Regarding building permit B 2100 2354  
(6734 Whitegate Rd), which is fully approved,  
please revise it per the new drawing  
package. The changes are outlined as  
follows:

14 May 2022  
6734 Whitegates Rd.

Floor Plan

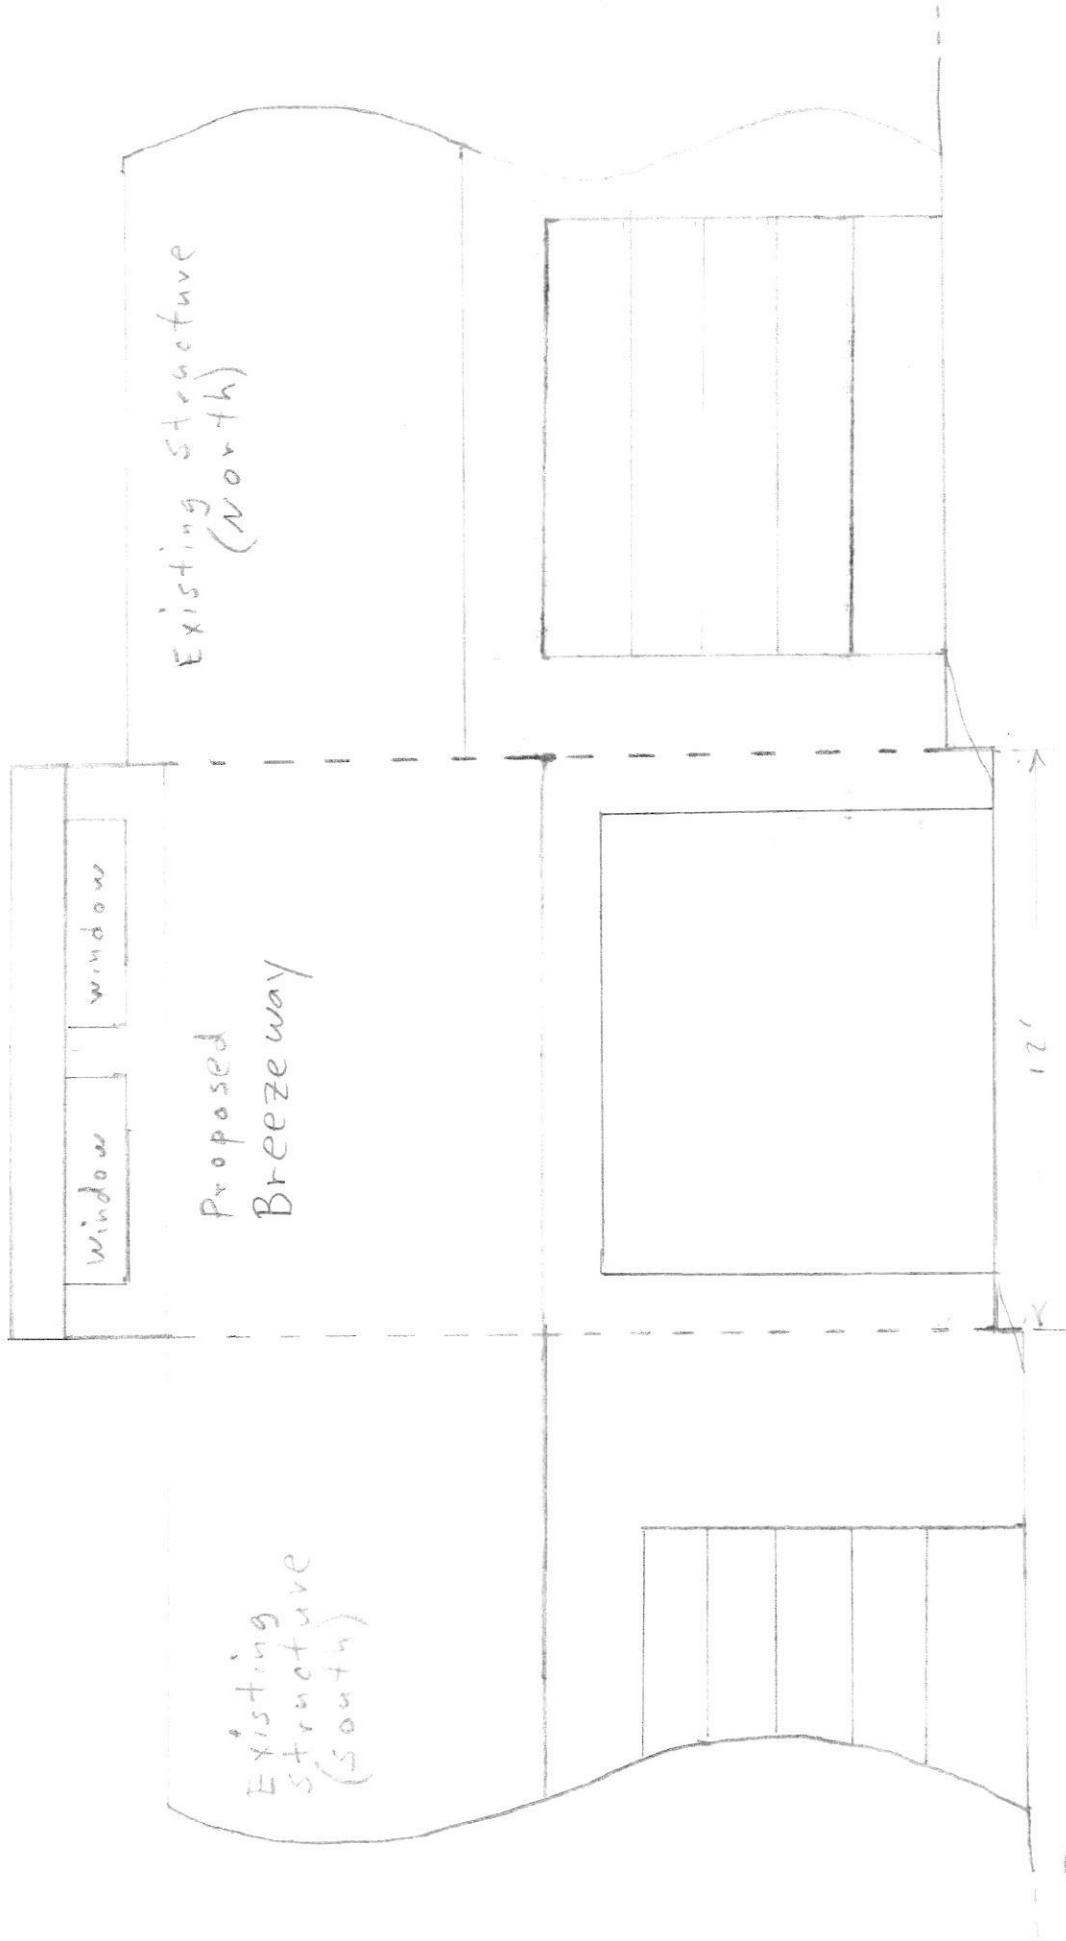
Header 1.75" x 9.5" LVL x 2

- Revisions:
- 1) Add window features to the roof line.
  - 2) Add support beams for the revised truss design.

DESC. = T-1 ATTIC  
 PLT. TYP.-WAVE

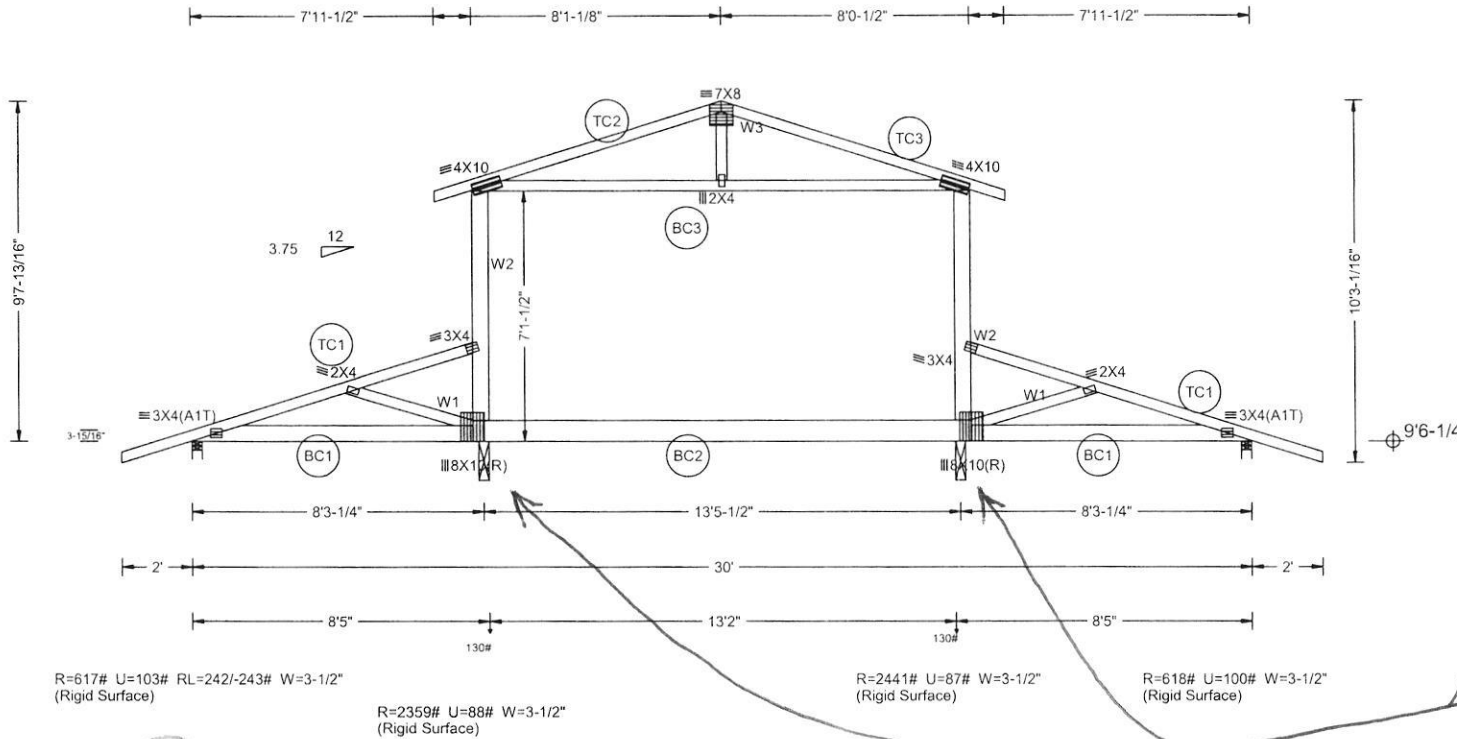
Tripple 1 3/4" x 11 7/8" LVL Beam for The Two Interior Supports.
